REPORT COA2018-011

FILE NO: D20-17-044

COPYRIGHT © IVAN B WALLACE OLS LTD 2015
SKETCH SHOWING PROPOSED SITING
39 MCGILL DRIVE
 GEOGRAPHIC TOWNSHIP OF MANVERS
CITY OF KAWARTHA LAKES

**Regarding: Minor Variance D20-17-044
39 McGill Drive, Part Lot 22, Registered Plan Number 33
Geographic Township of Manvers
City of Kawartha Lakes**

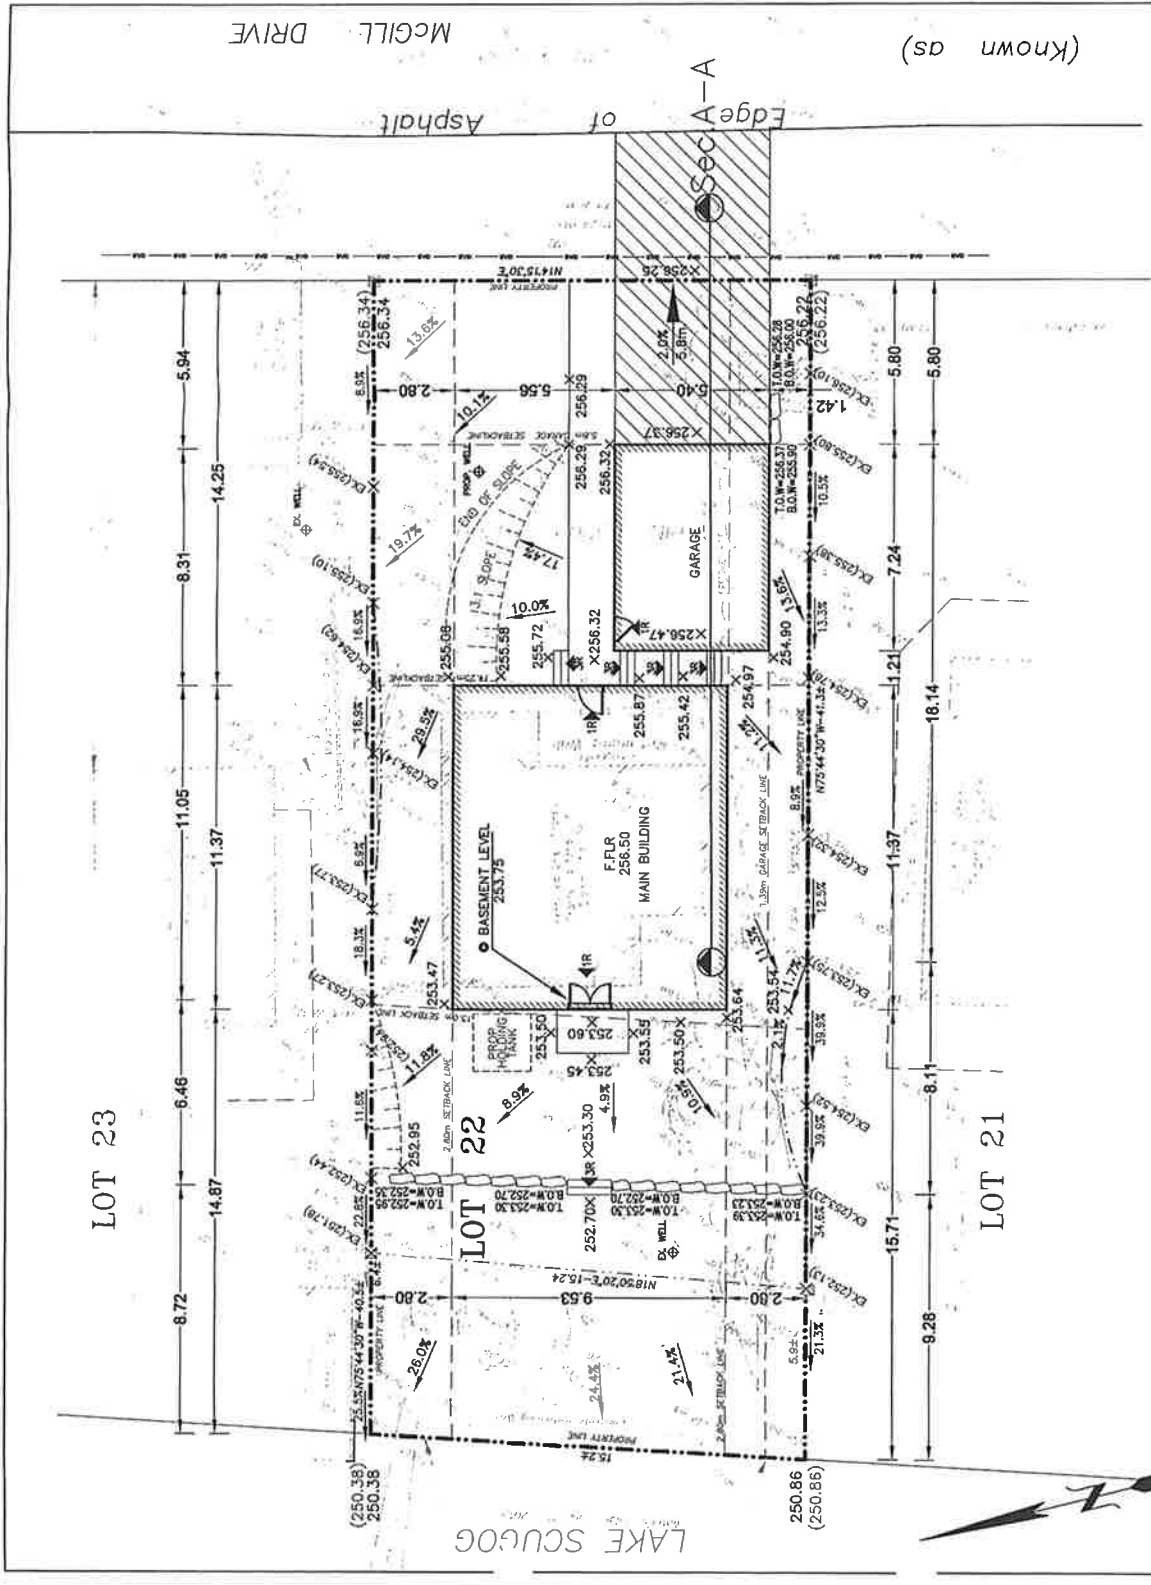
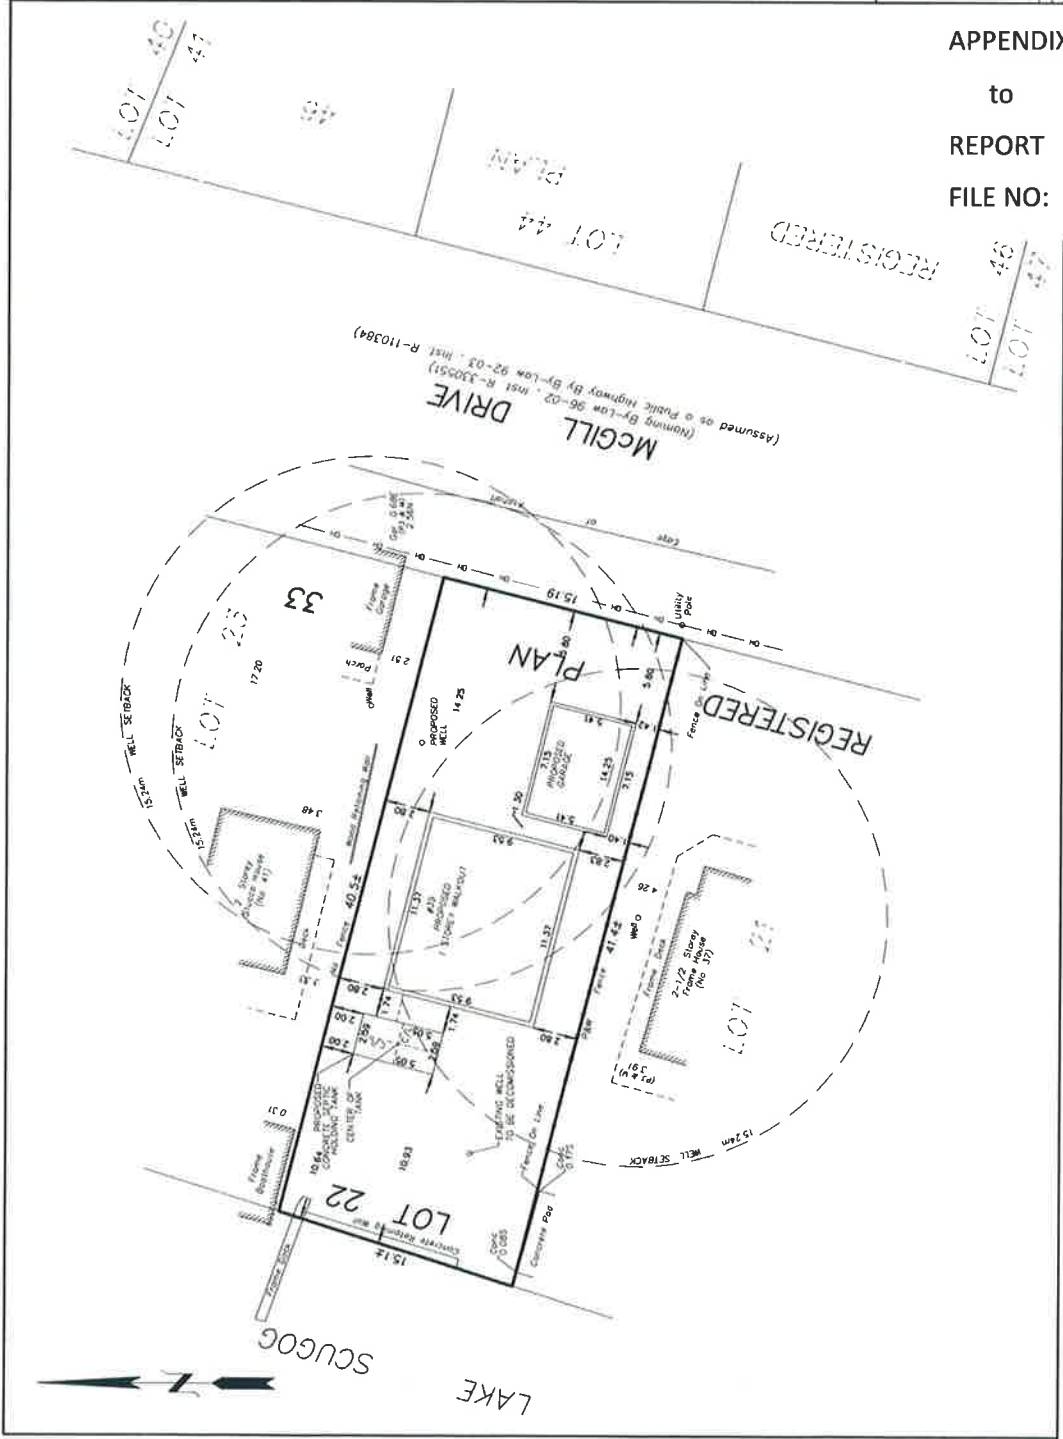
The *Lot Grading Plan, Lot 22, 38 McGill Drive, Plan 33, Lake Scugog Estates, City of Kawartha Lakes*, prepared by Can-America Engineering Inc., dated September 2017, submitted in support of this minor variance does not have the floodplain limit identified, however the topographic elevations ghosted on the plan and elevations provided in the legend demonstrate that the basement level is outside the floodplain at 253.75 masl.

I have received the revised diagram showing the new updated dimensions for the garage separation from the house. The clearances for the Class 5 Holding Tank have remained the same as the garage size was reduced. Thus, the Building Division – Sewage System Program has no further concerns with the revised survey dated February 6, 2018.

Anne, I noticed an error in the separation between the garage and dwelling, and had them correct it. The spatial separation was too small. Please find the updated plan attached for your review and comment.

Can you confirm this is the surveyor's sketch that you have on file for comment. The date is Dec 21, 2017 and shows the holding tank at a 2 m setback to the property line.

I have received an updated survey for the proposal at 39 McGill Drive for the location of the sewage system Class 5 holding tank, house, detached garage and well dated December 21, 2018 by IBW. This indicates the placement of the holding tank at 10.64m from the lake, 2m to the property line, 1.74m to the dwelling and 15m to neighbouring wells.

A review of the proposal as currently submitted is acceptable to the Building Division – Sewage System Program. Any deviations from this proposal, will require additional review from this office.

GARAGE SIDE ELEVATION

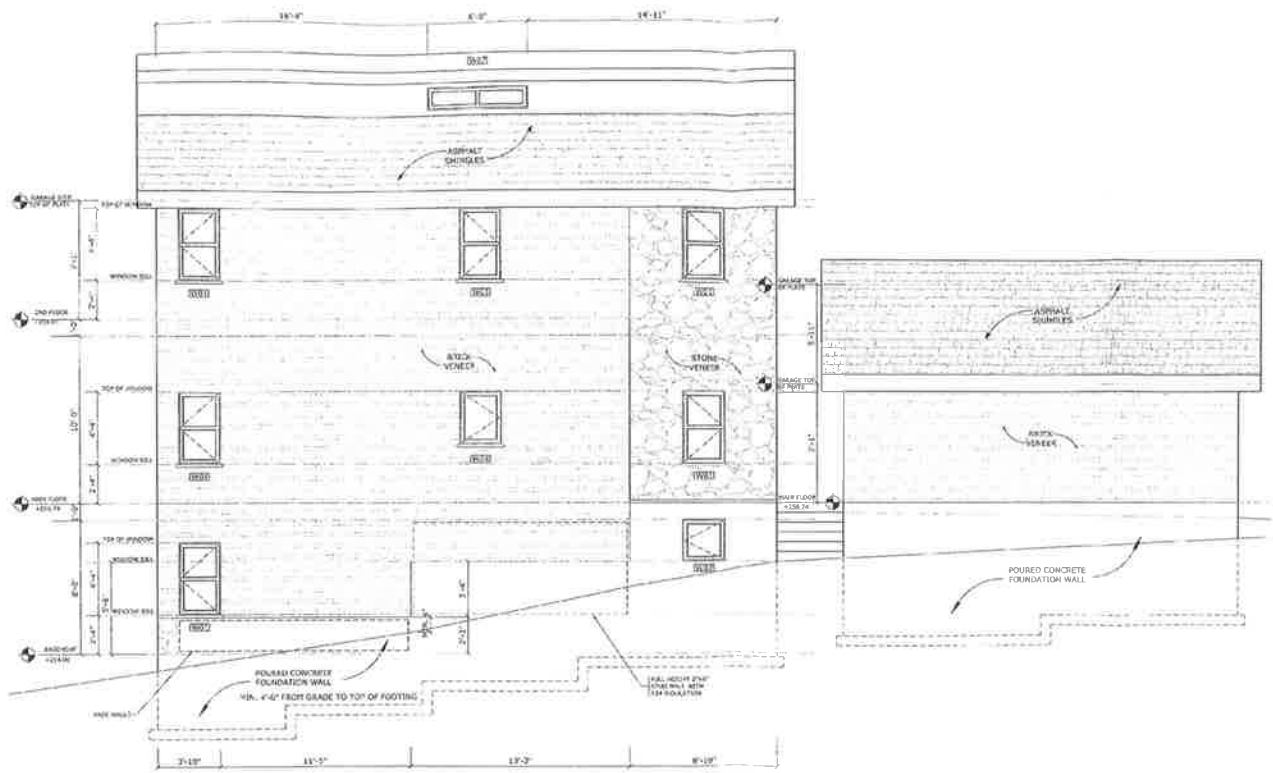
Although Elevation schedule of lot grading plan indicates a difference of only 0.15m house footing to garage footing, elevation drawing A09 clearly places the footing of the garage in an area of repose with respect to the dwellings foundation.
